STAFF REPORT: MAY 10, 2023 MEETING

APPLICATION NUMBER: 23-8330

ADDRESS: 85 CHICAGO

SCOPE: ERECT FRONT YARD ~~FENCE~~ HEDGE, INSTALL ASPHALT SHINGLE ROOFING, REPLACE FRENCH DOORS WITH WINDOWS, ~~ERECT REAR YARD FENCE AND DRIVEWAY GATE (WORK COMPLETED WITHOUT APPROVAL)~~

*Above: CertainTeed photos.
Left: Shenandoah color
Above: Installed Belmont shingles, color: Brownstone (staff couldn’t find a clear installed photo of Shenandoah).*

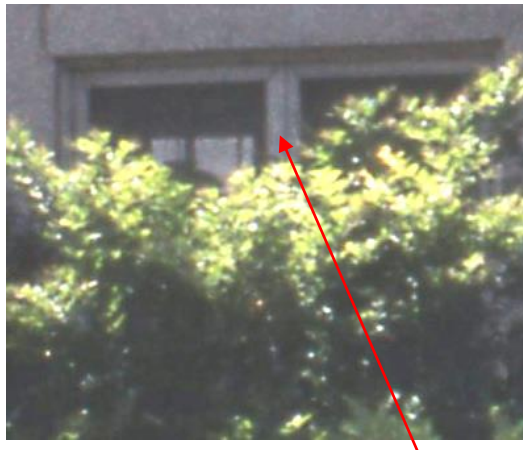
- The product proposed is **CertainTeed, Belmont asphalt shingles, color: Shenandoah. GAF, Grand Canyon (a line within the company’s “designer collection”) asphalt shingles, color: Stonewood.** The reason for the product change is due to estimated project cost.

- Based on staff's recent research, there doesn't appear to be an asphalt roofing company that currently produces an asphalt shingle that attempts to mimic the heavy vertical and rounded angular look of clay tile.
- Should the Commission consider an asphalt shingle, staff believes it must offer predominant vertical and horizontal lines and consistent color like a tile roof. It is staff's opinion the current proposal meets these criteria; the dark brown color is an appropriate choice for the architectural style of the house.

- The selected asphalt shingle roof does not emulate the profile, pattern, and singular color of the previously removed tile roof.

2023 staff photo

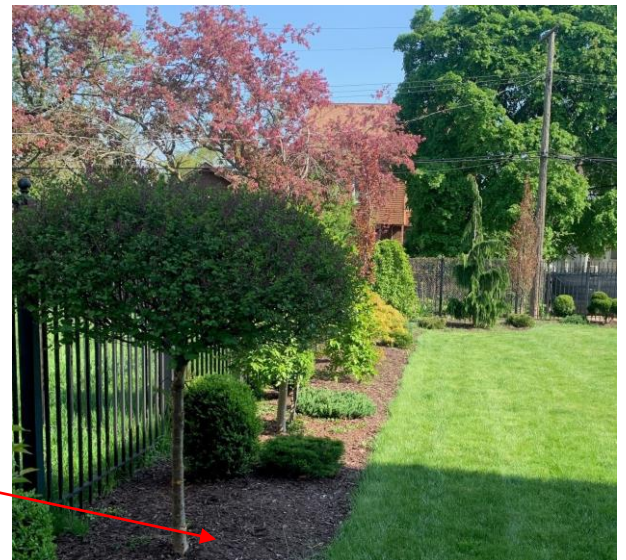
- Staff agrees with the homeowner’s assessment that the existing French doors are not original to the house. The historic photo clearly shows each door having a 2w x 5h glass pattern. It appears that these doors were intact at time of designation; the center muntin bar is visible in the left/eastern door in the 1974 photo. **However, the exterior framing of these glass units suggest they may have been full length casement windows with affixed screens as the exterior framing doesn’t show a wide mullion separating the units.** Staff didn’t find any HDC approval on file for their removal and replacement with the existing 3w x 5h panel wood doors, nor a date on when they were installed.

Applicant photos and site plan.

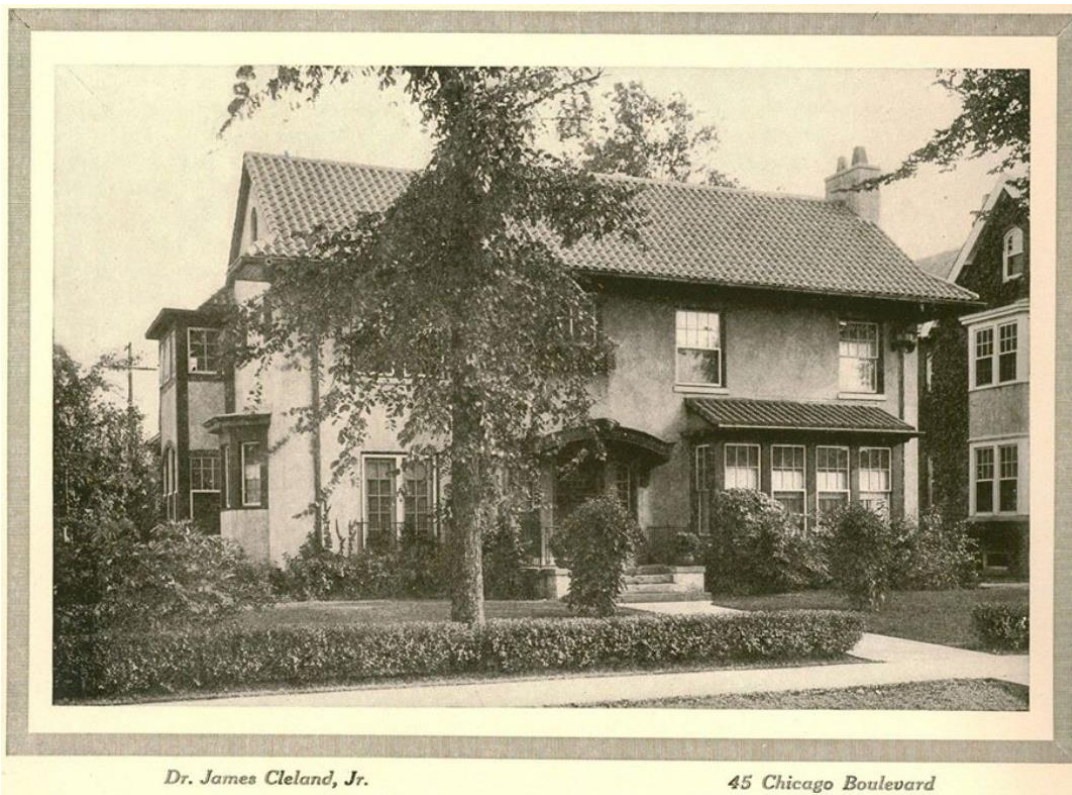
- The applicant revised the scope of work to include the installation of a continuous row of hedges (finished height 3' - 0") at the perimeter of the front yard, replacing the previously proposed fence. A gate at the front walkway is still proposed. Applicant submitted the two gate photos as design options.

- A hedge is a design feature that is in keeping with the district and the architectural style of the house; it was present in the historic photo. The selection of a metal gate, rather than wood, is an appropriate material for the architectural design of this house.
- There are only a few examples of front yard fences (e.g., 70 Boston, 90 Edison) within the Boston-Edison district that enclose the house, rather than enclosing a vacant lot. The remaining front yard enclosures are short hedge rows. The absence of front yard fencing allows the district to retain a comprehensive and unifying landscaped appearance.
- On Chicago, there is only one chain link fence that has been erected around an empty corner lot that includes most of the front yard and is adjacent to the house at 130 Chicago, located at the northeast corner of Chicago and Second.

- A revised site plan confirming hedges, and the type of hedge, will be planted at the perimeter of the front yard, and that the maximum height will not exceed 3'-0".
- A catalog cut of the iron or aluminum gate design will be submitted for staff review and approval prior to its installation.
- A catalog cut and/or measured drawing of the Juliet balcony that confirms its design, material, finish, and dimensions will be submitted for staff review/approval.
- The Pella windows will be revised to offer a six-over-six pattern, and a neutral cladding color will be selected. The revised order will be submitted for staff review/approval.

Above right: rendering from Pella window order. Above: exterior cladding colors from Pella brochure.

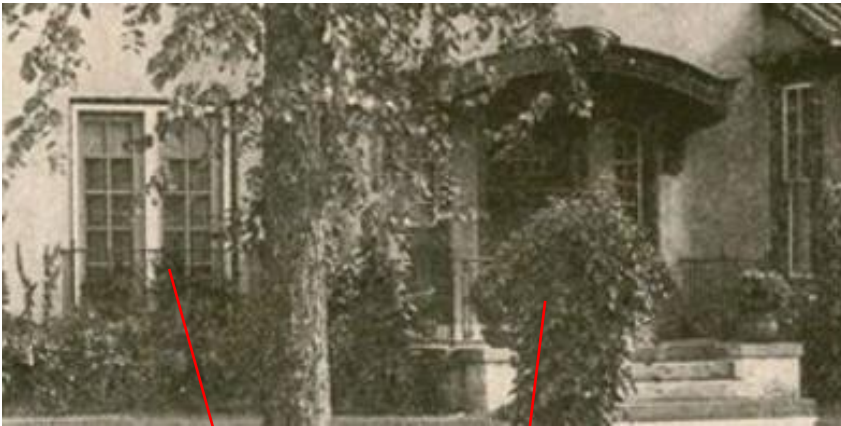
- It is staff's opinion that the French door opening is a distinctive character-defining feature of the house and property. The French door's sill and header match the height of those of the front door, and the elongated door opening counterbalances the verticality and openness of the windows in the box bay. **The applicant's current proposal is to retain the door opening and install two customized double-hung windows.** Staff believes this is an appropriate solution as it retains the historic opening, and a replacement product is already in place. However, the muntin pattern should be revised to six-over-six.

- The selected cladding color is brown. It is staff's opinion the dark color is not appropriate for the house as the frames would offer too much of a contrast against the stucco. Italian Renaissance houses typically have lighter colored window frames and trim, similar to the exterior wall material. As the stucco has been painted, staff isn't recommending the new windows match the existing stucco, rather a more neutral tone be selected for the window frames. Also, a factory mullied double window unit is proposed. Based on the historic photo of the exterior screen framing, staff believes a thin factory mullion is appropriate in this location.
